Item 8.1

DETAILED ASSESSMENT REPORT
 DEVELOPMENT PERMIT FOR SHORT TERM
 ACCOMMODATION
 MCU23/0125

APPLICATION SUMMARY	
Division:	5
Applicant:	Geoffrey Thomas Family Trust
Consultant:	Adams & Sparkes Town Planning
Owner:	Presidential Capital Pty Ltd Tte
Proposal:	Development Permit for Material Change of Use of Premises to Establish Short Term Accommodation
Properly Made Date:	24/05/2023
Street Address:	862 & 894 Landsborough-Maleny Rd BALD KNOB QLD
RP Description:	Lot 1 SP 256087 & Lot 3 SP 311048
Assessment Type:	Impact
Number of Properly Made Submissions:	The application was publicly notified for 15 business days between 11 December 2023 and 18 January 2024 in accordance with the requirements of the Planning Act 2016. A total of 2 properly made submissions was received objecting to the proposed development.
State Referral Agencies:	<u>Concurrence</u> <ul style="list-style-type: none"> SARA at DSDILGP (State Controlled Road)
Referred Internal Specialists:	<ul style="list-style-type: none"> Economic Development Branch Development Services Branch: <ul style="list-style-type: none"> Principal Development Engineer Senior Landscape Officer Senior Environmental Management Officer 3D P

Figure 30 Applicant's engineering sections of proposed retaining wall adjacent the site's frontage

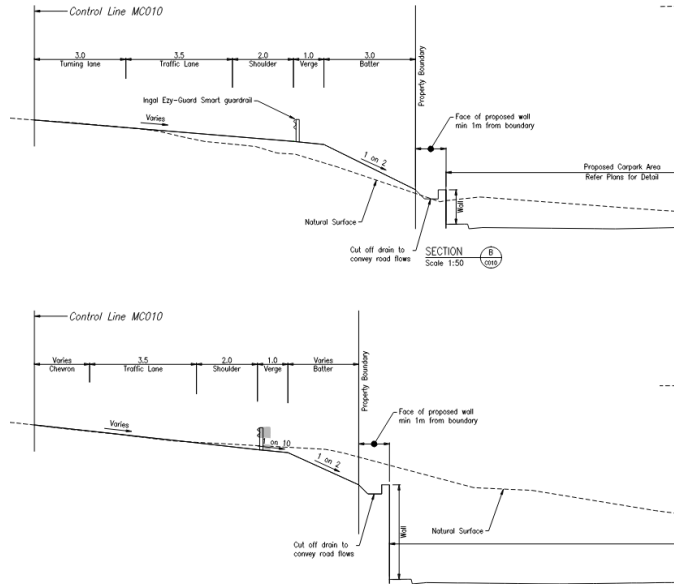
- A retaining wall is proposed adjacent to the majority of the frontage of the site associated with the proposed car park, which is set back a minimum of 1m from the property boundary.
- The proposal indicates an offset of the retaining walls from the front boundary of approx. 750mm for the majority of the frontage, with 2 larger areas for landscape at either end of the car parking area. The space of 750mm would be insufficient to accommodate planting capable of screening the car park and just as critically the built form.
- At the top of the retaining wall the submitted engineering plans show a cut off drain proposed for stormwater overland flow interception and conveyance. Planting/landscaping within this drainage infrastructure will be very limited (if any).

- The width of landscaping space at the base of the proposed retaining wall is very limited (approx. 600mm). This width is insufficient to accommodate species that could achieve a height to screen the built form from the road, with such a narrow width not being conducive to the growth of plants.

Figure 31 State referenced plan showing extent of landscaping restrictions

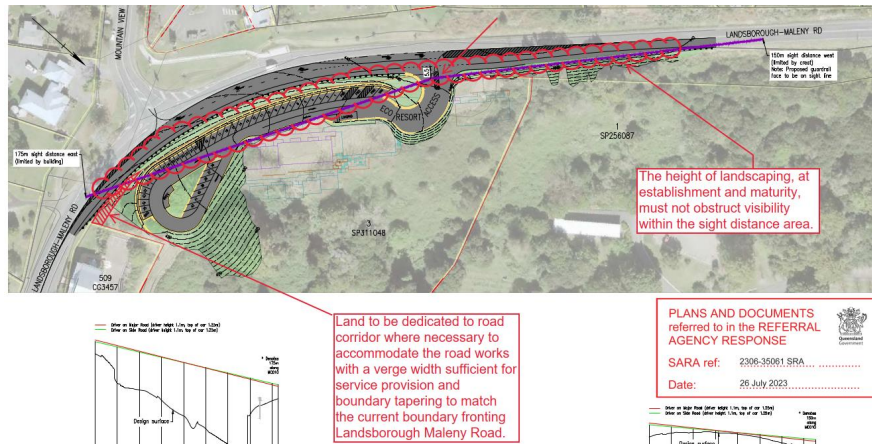
- The conditions imposed by the State (for state controlled road impacts) limit planting along the entire frontage of the site so as to not obstruct visibility for vehicles exiting the site, which means landscape must be less than 1m high (both within the site and within the road reserve). In addition, there are conditions requiring front boundary fencing be provided for the length of the frontage (due to the steep drop off), which may further impact upon landscape outcomes.

- The applicant’s landscape concept plans indicate substantial verge planting to assist in screening the built form. This is not considered feasible given the aforementioned constraints.
- The application material indicates two storage tanks associated with greywater and blackwater treatment. No detail has been provided around the height of these tanks or what landscape could feasibly be provided in these two locations.
